Project Title
North Irish Sea Array Offshore Windfarm

Drawing Title
Grid Facility Layout Plan Sheet 1 of 2

Name 281240-ARP-ONS-GF-DR-PL-1001

Rev C03

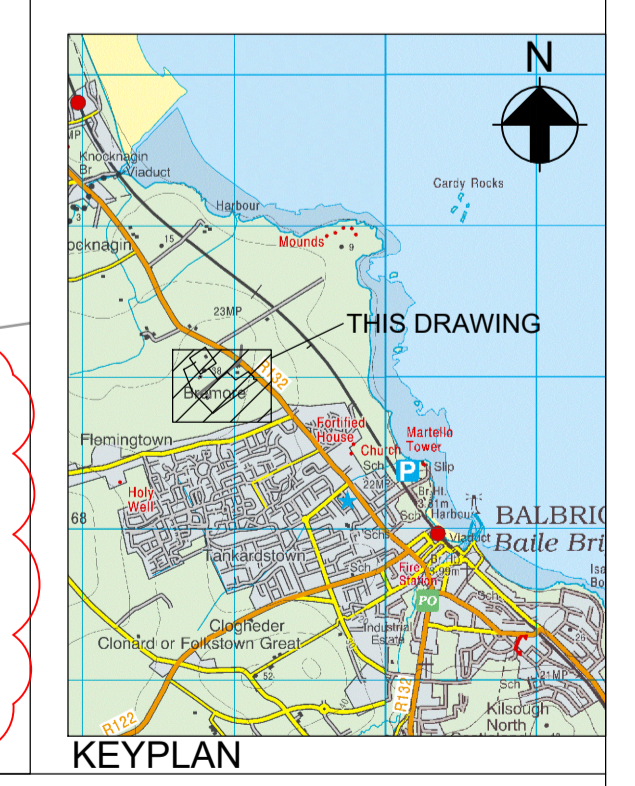
- AN 8m HIGH ENVIRONMENTAL ENCLOSURE HAS BEEN UPDATED TO BE FULLY ENCLOSED ON 3 SIDES AND INCLUDE ACOUSTIC MATERIAL TO REDUCE NOISE IMPACTS FROM THE HARMONIC FILTERS ON FUTURE RESIDENTS OF THE FLEMINGTON LOCAL AREA PLAN (LAP) IN RESPONSE TO RFI SECTION 13 (E).

THIS DRAWING HAS BEEN UPDATED TO REFLECT THE REVISED LANDSCAPE MANAGEMENT PLAN WHICH HAS BEEN PREPARED IN RESPONSE TO RFI SECTION 13 (E). AS PART OF THIS PLAN, THE SITE PERIMETER FENCE HAS BEEN CHANGED FROM A PALISADE FENCE TO A CONCRETE POST-AND-RAIL FENCE.

IN ADDITION, THE LIGHTNING ARRESTOR MASTS AND LIGHTING COLUMNS HAVE BEEN CLEARLY ANNOTATED FOLLOWING RECEIPT OF FINGAL COUNTY COUNCIL'S OBSERVATIONS.

THIS DRAWING HAS BEEN UPDATED TO INCLUDE ACOUSTIC ENCLOSURES (NOTE 6 AND 7) AND REFLECT THE REVISED LANDSCAPE MANAGEMENT PLAN WHICH HAS BEEN PREPARED IN RESPONSE TO RFI SECTION 13 (E). AS PART OF THIS PLAN, THE SITE PERIMETER FENCE HAS BEEN CHANGED FROM A PALISADE FENCE TO A CONCRETE POST-AND-RAIL FENCE.

IN ADDITION, THE LIGHTNING ARRESTOR MASTS AND LIGHTING COLUMNS HAVE BEEN CLEARLY ANNOTATED FOLLOWING RECEIPT OF FINGAL COUNTY COUNCIL'S SUBMISSION.
